Work Order ID 108744

D3290-041 REPLACEMENT WINDOW ASSEMBLY

DRAWING NO.	TITLE	REV. C	DART AEROSPACE LTD	D.E.O. NO.	SHEET NO.	SCALE
D3290	REPLACEMENT WINDOW ASSEMBLY		ENGINEERING ORDER	D3290-C-1	SHEET 1 OF 1	NTS
DRAWN	CHECKED		MFG. APPR.	APPROVED	DE APPR.	
DATE 09.09.18	DATE 09.09.18		DATE 09.09.18	DATE 09/09/21	DATE 09/09/21

PURPOSE:

D3290-1 FRAME

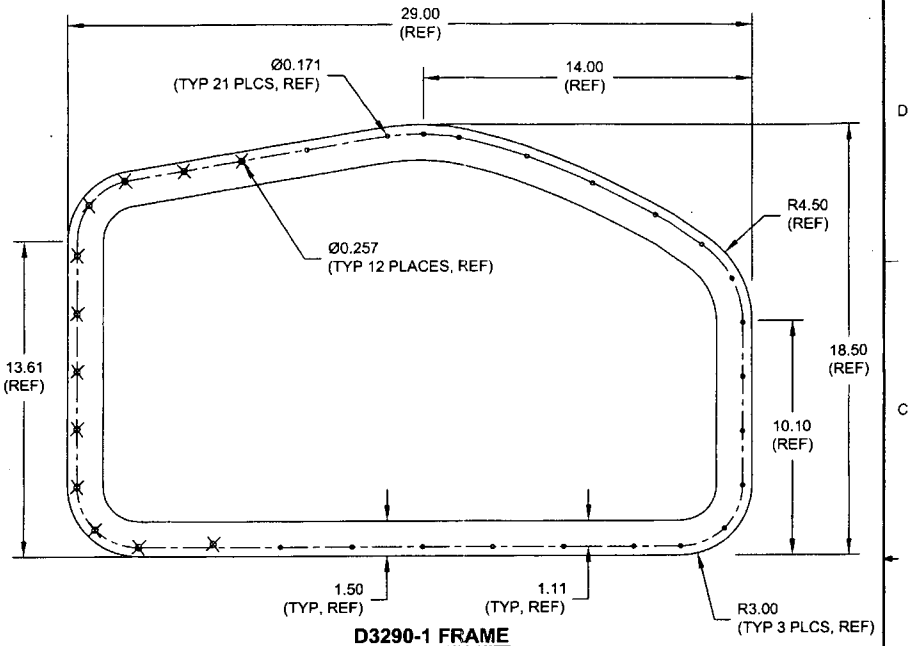
CHANGE MATERIAL THICKNESS OF D3290-1 FRAME TO 0.063 FROM 0.040. REF PAR 09-033.

MATERIAL CALL-OUT OF D3290-1 FRAME ON SHEET 1 IS AMENDED AS FOLLOWS:

1) MATERIAL: 6061-T6 (OR 6061-T62) ALUMINUM SHEET ~~0.040 THICK~~ 0.063 THICK (REPLACE)
PER AMS-QQ-A-250/11 OR AMS 4025 OR AMS 4027
~~(REF. DART SPEC. M6061T6S.040)~~ REF. DART SPEC. M6061T6S.063 (REPLACE)
OR
5052-H32 ALUMINUM SHEET ~~0.040 THICK~~ 0.063 THICK (REPLACE)
PER AMS-QQ-A-250/8 OR AMS 4016
~~(REF. DART SPEC. M5052H32S.040)~~ REF. DART SPEC. M5052H32S.063 (REPLACE)
